**Southern Utah  
Fuel Company**

SUBJECT: SUBSTATION MODIFICATION

SUBJECT: Main Fan Diversion Modification

<b>SOUTHERN UTAH FUEL CO. MINE NUMBER ONE</b>	
<b>69KV SUBSTATION GROUNDING</b>	
DATE 3-26-85	SCALE 1" = 10' 0"
DRAWN BY ADS	DRAWING NO. 88SELECT 114B

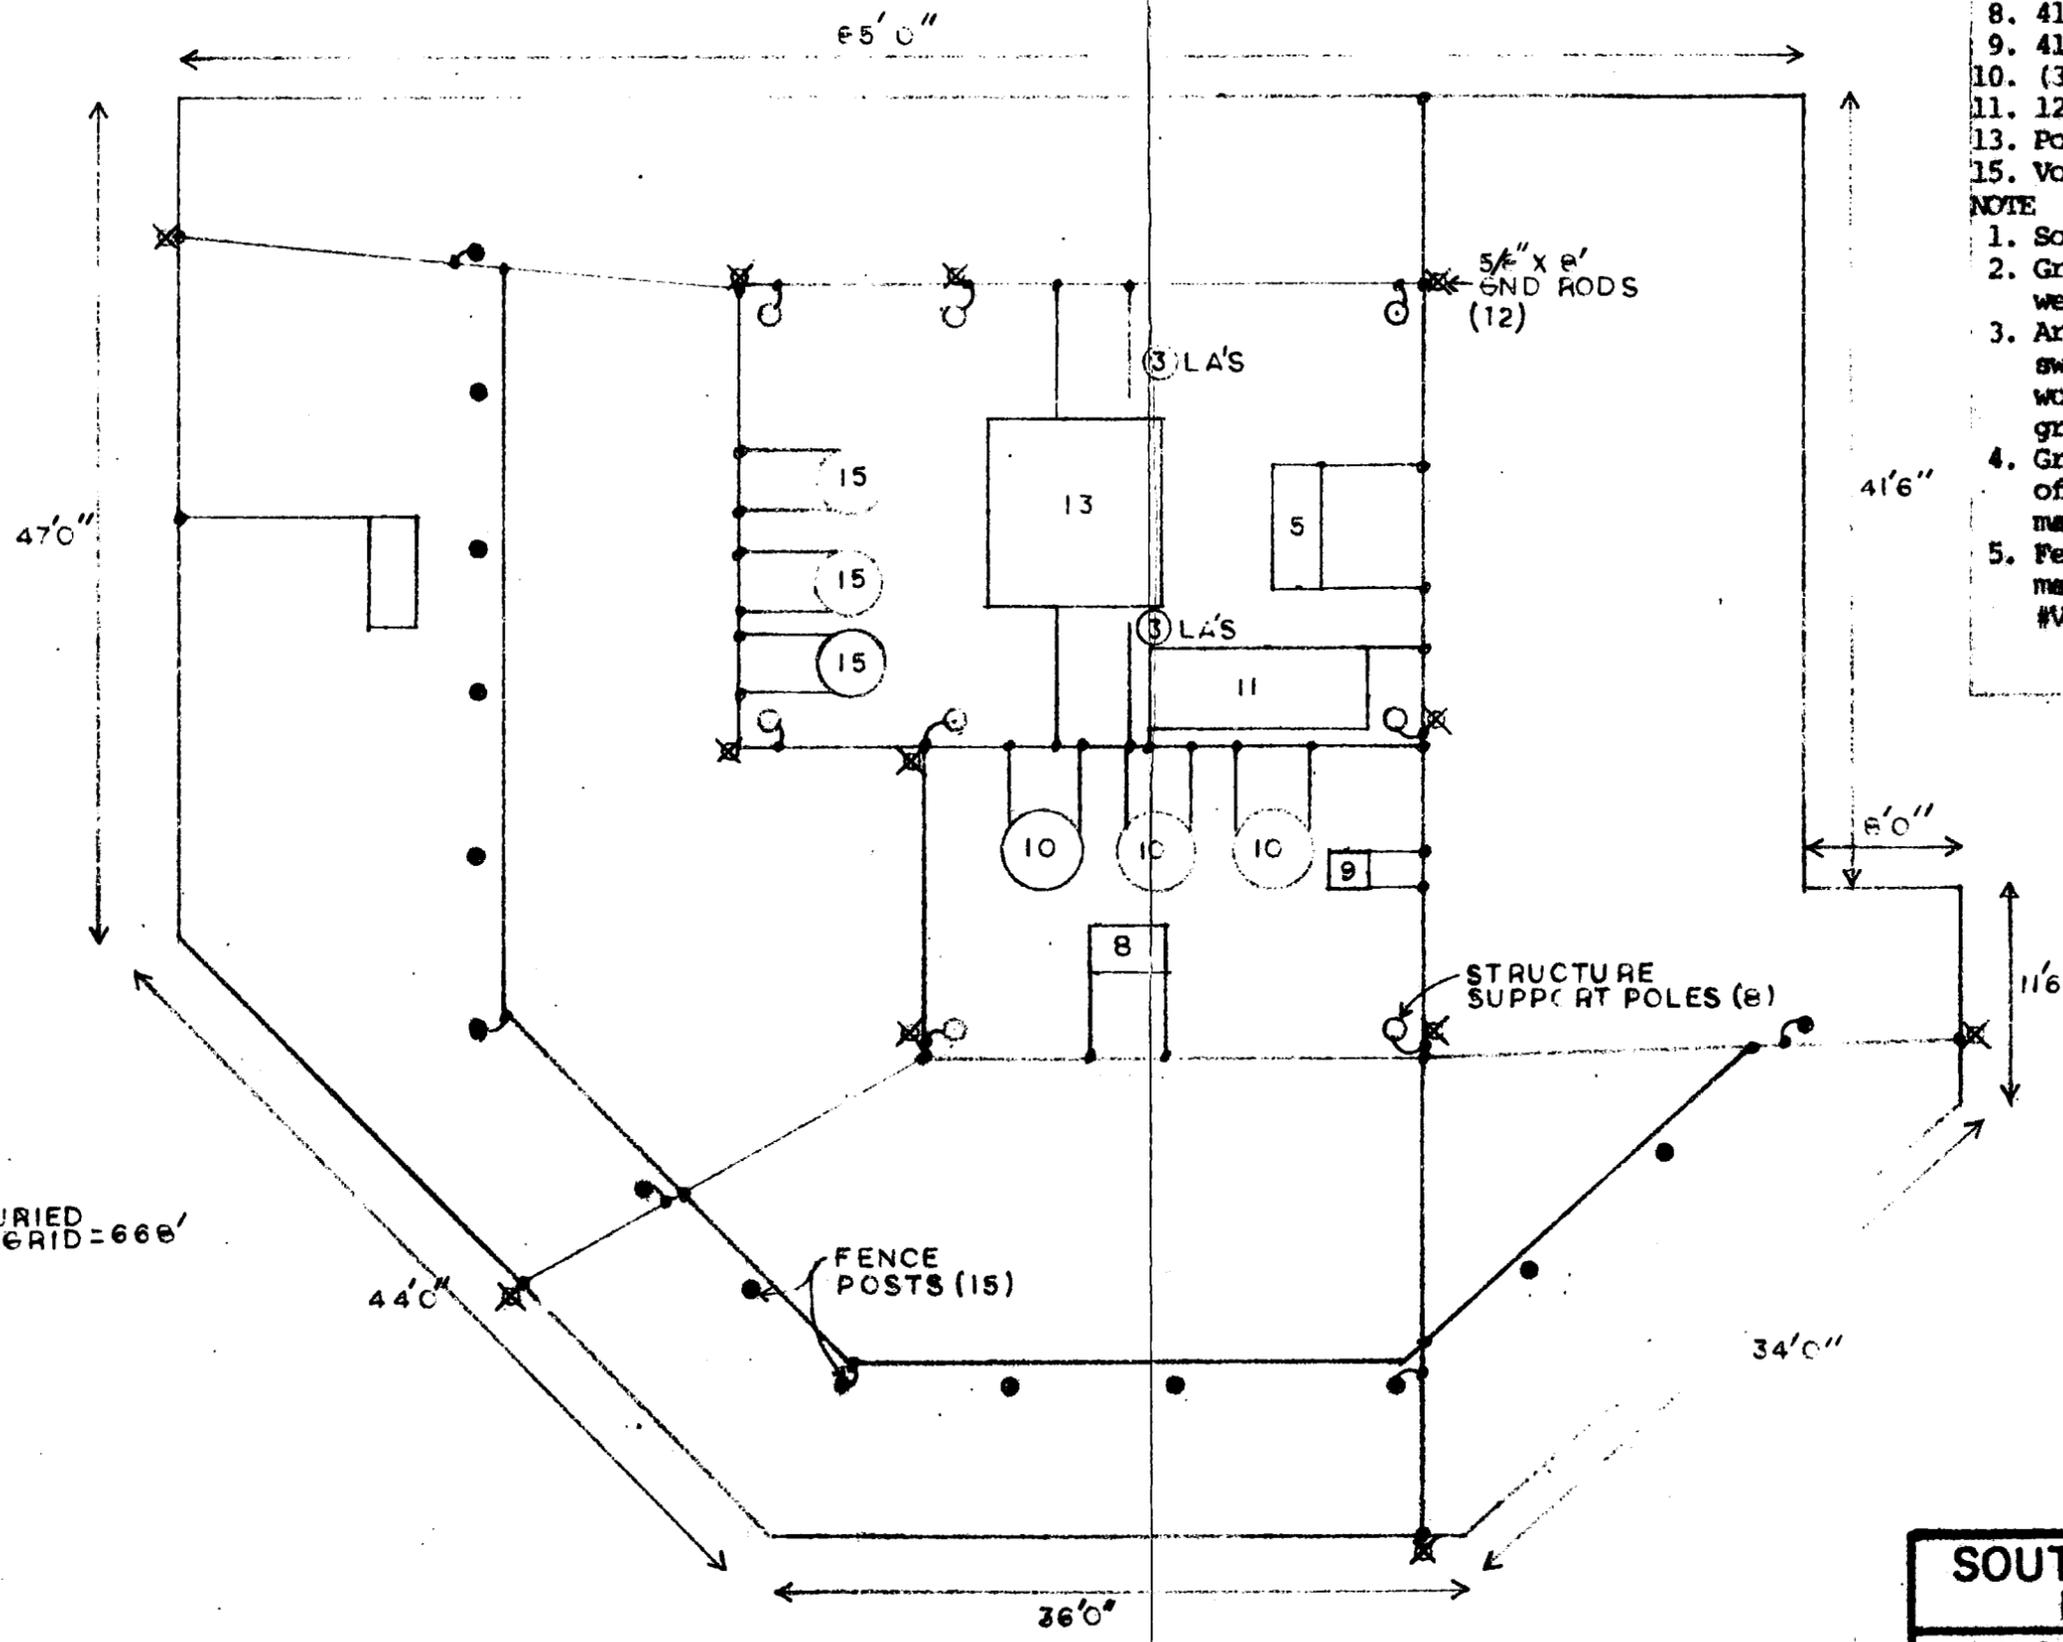
The modification project will consist of replacing the existing 25 kV/12.5 kV transformer with a 69 kV/12.5 kV transformer and expanding the existing fenced perimeter to gain required safety clearances. In addition, a grounding grid will be buried inside the fence and eight feet outside the conductive segments of the fence to conform with Utah Power and Light Company's current substation safety requirements (drawing 85 Elect 114B). The total area affected is within the disturbed area previously calculated for bonding; therefore, no additional reclamation cost is anticipated. See Map 85-4. Reclamation will be in accordance with the Consolidated Reclamation Plan provisions submitted to the Division on 4 April 1984, Volume 8.
